TDFOM normalization factor and corrigendum draft proposal

Luisma Torres
IEEE Std 802.3-2022/Cor 2 (IEEE 802.3dr) TF Meeting
Madrid, Spain
July 28th 2025

Proposal of Corrigendum to IEEE Std 802.3: TDFOM normalization

Table 166–16— BASE-AU TDFOM parameters

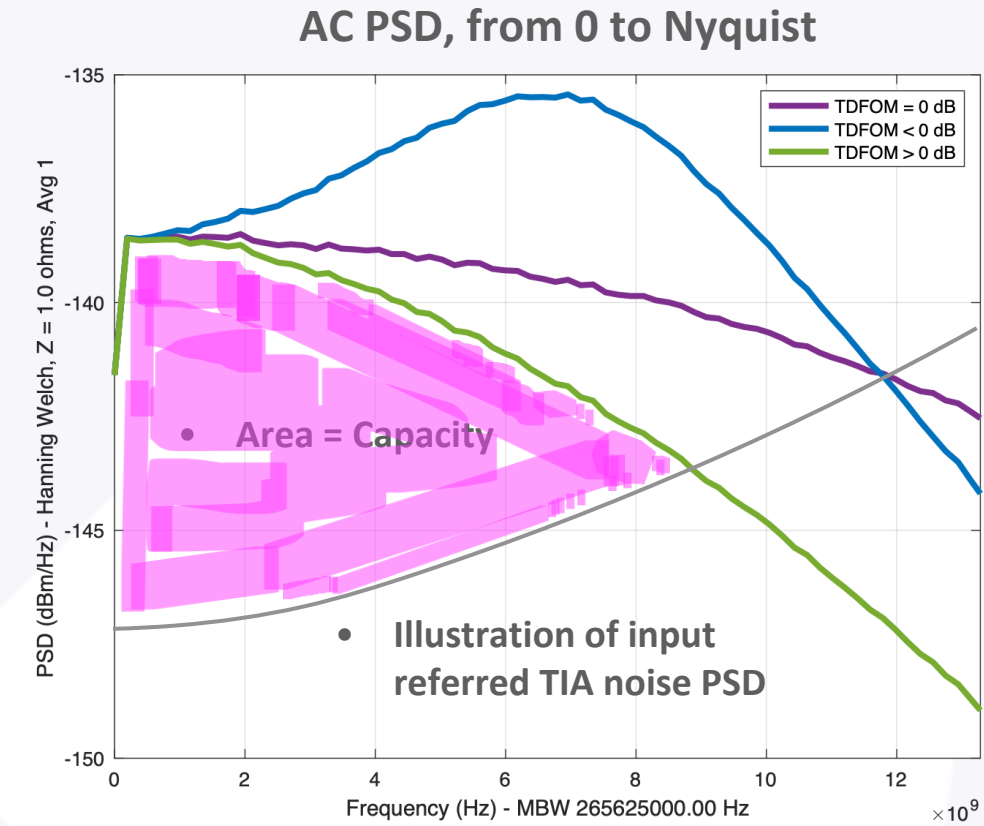
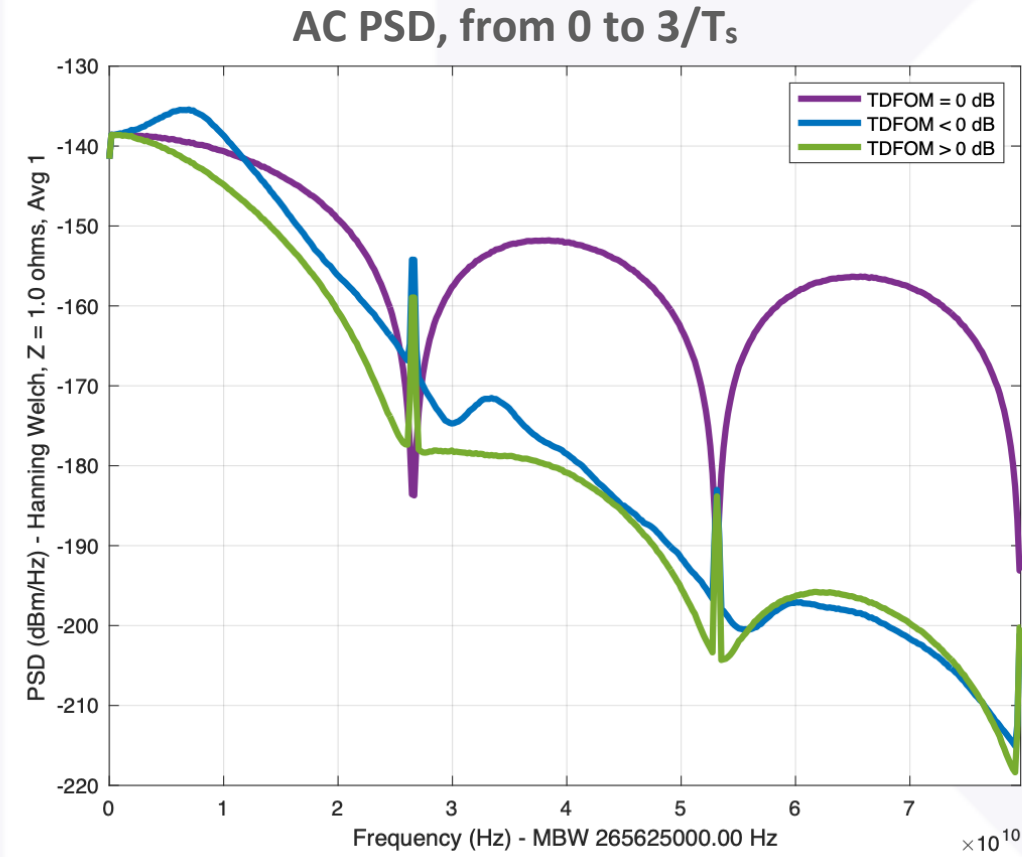
- *But first implementations of the algorithm had a fixed ϕ and $F(z)$ delay. Existing TDFOM₀ values in current IEEE Std 802.3 are based on this assumption*

- Current values without optimization of sampler delay ϕ
- Proposed values with optimization of sampler delay ϕ

Parameter	2.5GBASE-AU	5GBASE-AU	10GBASE-AU	25GBASE-AU	50GBASE-AU	Units
M	2				4	—
Q_0	3.5741 ^a				3.4981 ^a	—
$TDFOM_0$	3.72	3.74	3.77	3.90	2.83	dB
